AMENDMENT OF SOLICITATION/MODIFICATION OF CONTRACT					1. CONTRACT ID CODE J		PAGES
2. AMENDMENT/MODIFICATION NO.	3. EFFECTIVE DATE	4. REQUISITION/PURCHASE REQ. NO.		5. PROJECT 1	NO.(If applic	able)	
0001	12-Jan-2004	88XGR-3316-3205			41

D. OTHER (Specify type of modification and	d authority)						
E. IMPORTANT: Contractor is not,	is required to sig	gn this document and return	copies	to the issuing	g office.		
 DESCRIPTION OF AMENDMENT/MODIF where feasible.) This solicitation for Upper Camp Creek Interce 2004 at 2:30 p.m., is amended as follows: 	-				-

W912EQ-04-B-0004

BEDDING / BACKFILL DETAIL

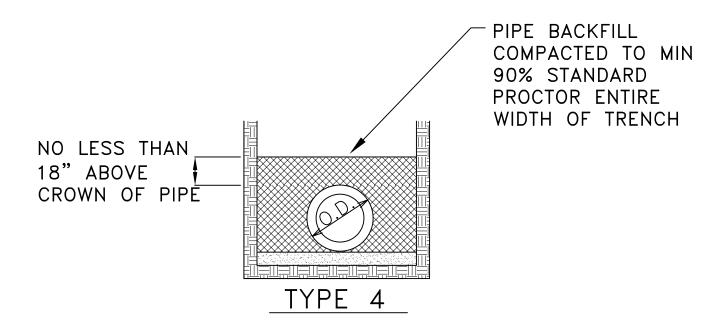
- 8. SECTION 2560: Add Bedding Detail sketch to the end of this section.

PIPE BEDDED MATERIAL PER
SPECIFICATIONS TO DEPTH OF 1/8 PIPE
DIAMETER, 6" MINIMUM. BACKFILL
COMPACTED TO TOP OF PIPE.
(MINIMUM 90% OF STANDARD
PROCTOR, AASHTO T-99)
